MILITARY SPECIFICATION

MODULES, STANDARD ELECTRONIC

TRANSFORMER, SCOTT-T, ANALOG, KEY CODE STT

This amendment forms a part of MIL-M-28787/185B(EC), dated 3 February 1982, and is approved for use within the Space and Naval Warfare Systems Command, Department of the Navy, and is available for use by all Departments and Agencies of the Department of Defense.

FIGURE 5. Stress test circuit for table IV.

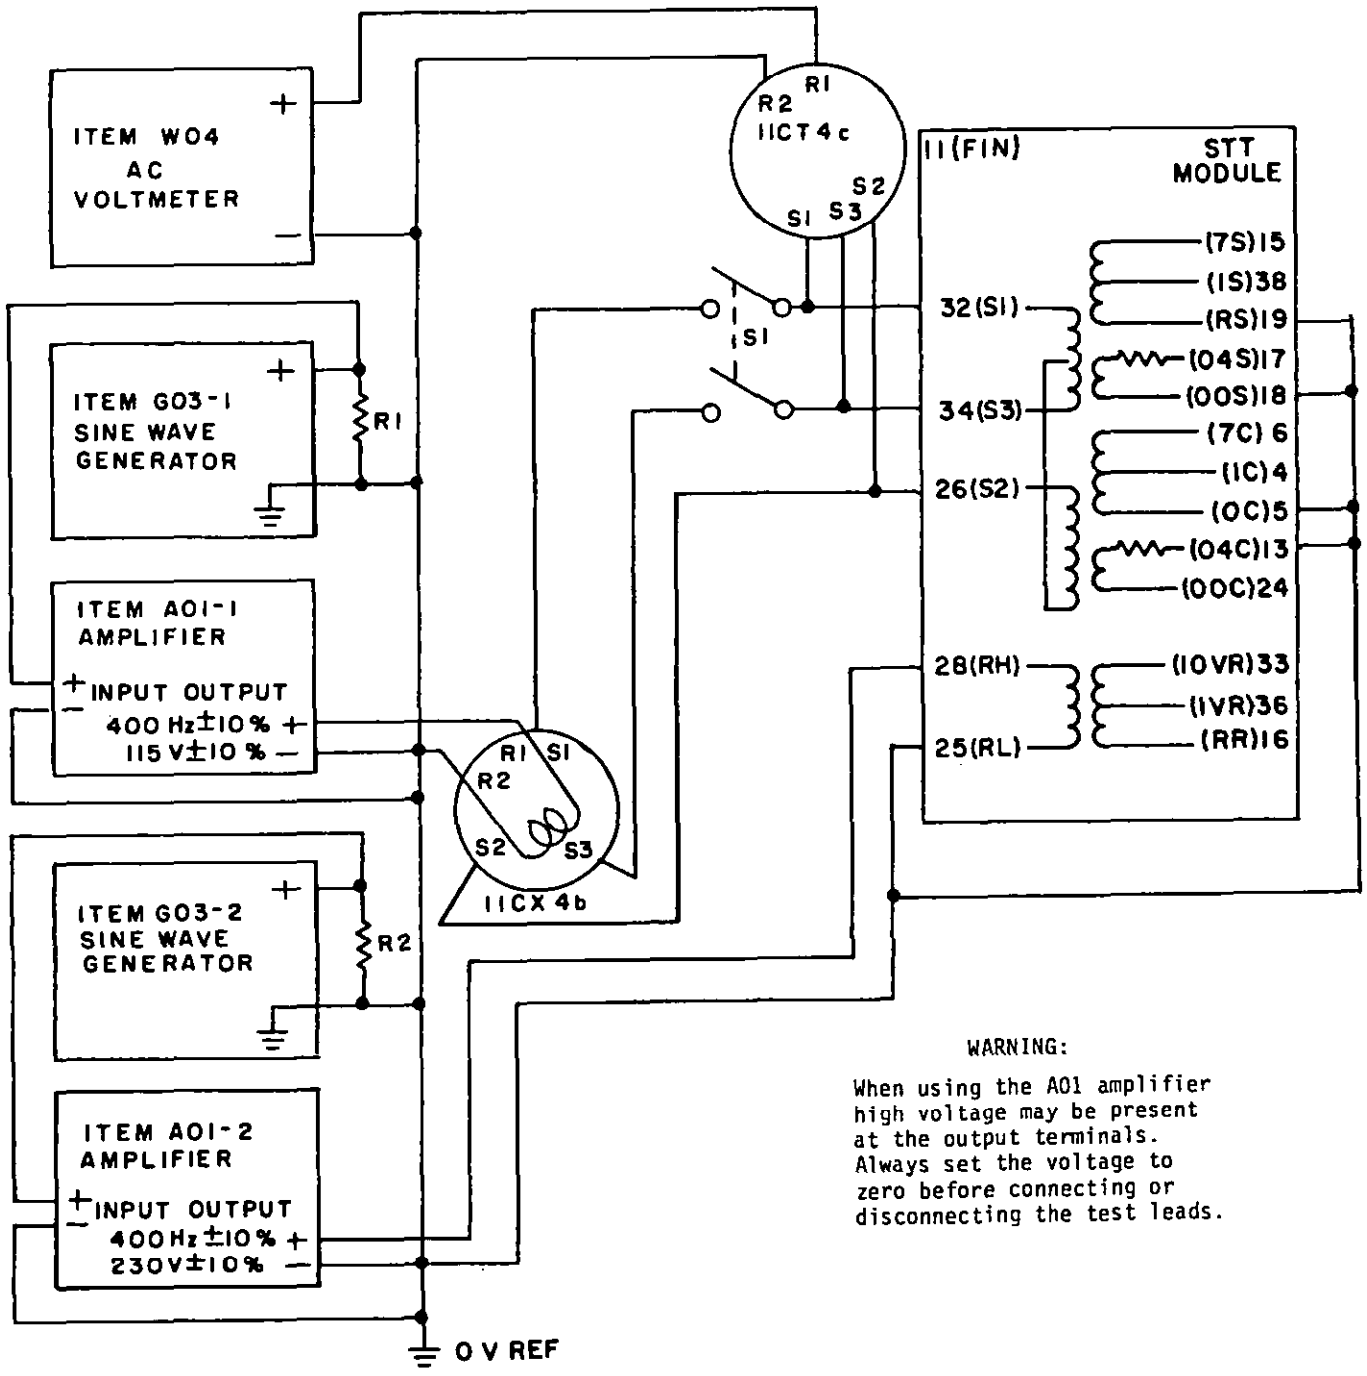
FIGURE 5: Delete and substitute new figure 5 as printed on page 3 of this amendment.
